Richard Downes , S9, Sunhill Dairy, Dad- 645 The Gap Rd Salisbury Plains – Approx 6km East of Uralla

Objections to The 'New England Solar Farm' Development -Approx. 6kms East of Uralla

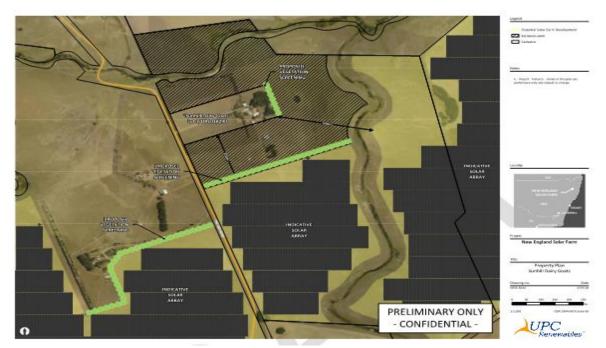
Photo B4 in the EIS was taken from just behind this gate.

I wouldn't class it as a representative view
